UNITED STATES PATENT AND TRADEMARK OFFICE

Office Action Summary	Application No. 10/561,637	Applicant(s) KAWAI ET AL.	
	Examiner William V. Gilbert	Art Unit 3635

DETAILED ACTION

Claim Rejections - 35 USC § 103

Figure 6 from Odell

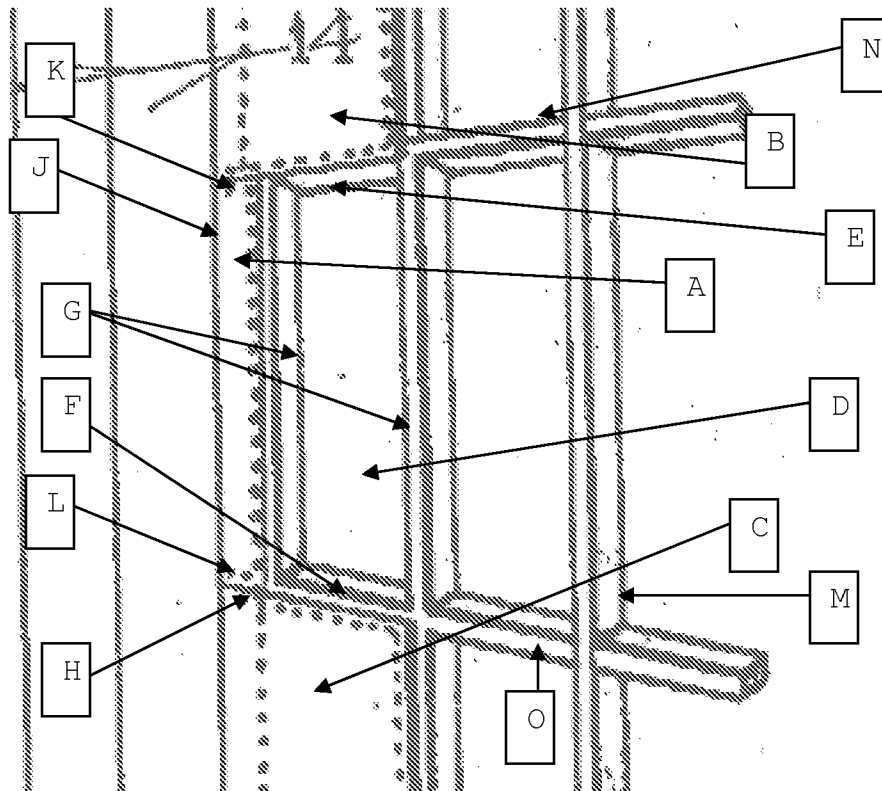
Claim 4: Odell discloses a construction of a wall opening (see Fig. 6, "D" below) in a house comprising:

a first side face wall frame member ("A" from attached Fig. 6, below) laterally spaced from a second side face wall frame member (the side opposite "A" below; not shown in the drawing but would be present);

an opening upper frame member ("E") disposed between said first side face wall frame member and said second side face wall member;

an opening lower frame member ("F") located below said opening upper frame member, said opening lower frame member disposed between said first side face wall frame member and said second side face wall frame member (as shown);

said first side face wall frame member having an inner vertical longitudinal frame member ("G") located adjacent the side wall opening, said inner vertical longitudinal frame member having an upper end and a lower end;

said first side face wall frame member having an outer vertical longitudinal frame member (would be behind portion "J"; see Figure 2 which shows that frame members are placed at the edges of panel members) with an upper transverse frame member (would be behind portion "K" below) disposed between said upper end of said inner vertical longitudinal frame member and said outer vertical longitudinal frame member and a lower transverse frame member (would be behind portion "L" below) disposed between said lower end of said inner vertical longitudinal frame member and said outer vertical longitudinal frame member;

said second side face wall frame member having an inner vertical longitudinal frame member (equivalent to portion "G" on the opposite side) located adjacent said wall opening, said inner vertical longitudinal frame member having an upper end and a lower end;

said second side face wall frame member having an outer vertical longitudinal frame member ("M") with an upper transverse frame member ("N") disposed between said upper end of said inner vertical longitudinal frame member and said outer vertical longitudinal frame member and a lower transverse frame member ("O") disposed between said lower end of said inner vertical longitudinal frame member and said outer vertical longitudinal frame member;

a first side face wall (proximate "A") fixed to said first side face wall frame member;

a vertical wall panel ("B") having a lower end fixed to said opening upper frame member and said first and said second side face upper frame members;

a wainscot wall panel ("C") having an upper end fixed to said opening lower frame member and said first and said second side face lower frame members;

Odell does not disclose the upper and lower frame members (applicant's 154 and 157) as claimed. Bailey discloses that it is known in the art to place such members in framing systems (see Fig. 15: 1 and proximate 19). It would have been obvious at the time the invention was made to a person having ordinary skill in the art to have the frame members as shown in Bailey with the system in Odell because having members placed in this manner insures adequate strength for a frame system. Further, It would have been obvious at the time the invention was made to

Last, Odell does not disclose that the system is made of steel, though Howell discloses a steel framing system used for construction (Col. 2, lines 20-25). It would have been obvious at the time the invention was made to a person having ordinary skill in the art to use a steel system as disclosed in Howell because it is well known in the art to use steel framing due to its strength and durability and longer life over a wood counterpart.

Regarding applicant's argument with respect to the Odell reference (cited above; arguments p 7), the examiner respectfully disagrees. While noting that Odell does teach that the panels are to be staggered, the examiner's notation that the figures teach an opening is maintained. Openings are well known in the art for various applications, and as shown, the figures disclose "an opening". Applicant respectfully provides in the claim language "a construction of a wall opening". The claim language does not provide any other limitations to define the opening. As a result, the examiner maintains the rejection as proper
